GE Lighting

Re: **GE Lighting Comments on ENERGY STAR Program Lamp Specification v1.0 Draft 3**

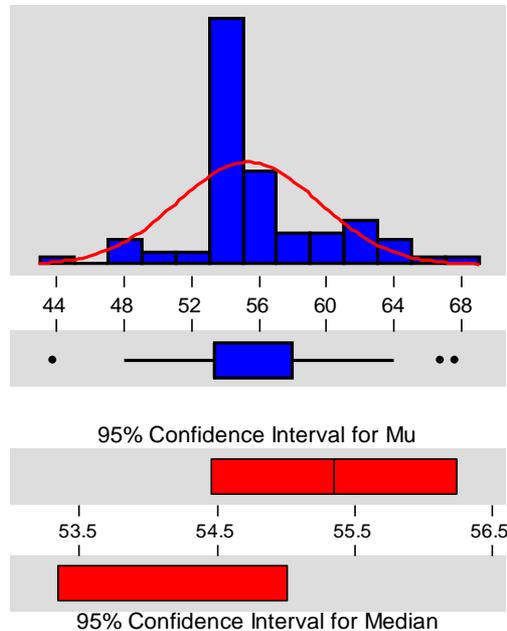
Parameter	CFL v4.3	Lamps v1.0 Draft 2	Lamps v1.0 Draft 3	Consequence
LPW	Bare ≥ 15 w: 65lpw, Covered ≥ 15 w: 50lpw Reflectors: 33 or 40 LPW (if ≤ 20 W)	Bare ≥ 10 w: 60lpw, Covered (A-line) ≥ 10 w: 60lpw Directional ≥ 10 W: 45 LPW Deco ≥ 10 W: 50LPW	Bare ≥ 15 w: 65 lpw, Covered (A-line) ≥ 15 w: 65lpw Directional 40 or 50 LPW (if ≤ 20 W) Deco: 45 or 50 LPW (if $\leq \geq 15$ W)	Industry wide A-line shape lamps would not meet spec. . See data analysis from EPA data base (next sheet) No A-line CFL's with ES logo will be on the shelves 43 current GE models approved at v4.3 Technically impossible to improve to the bare spiral level

GE recommendation: Split bare spiral and A-line shape covered lamps into 2 different categories:
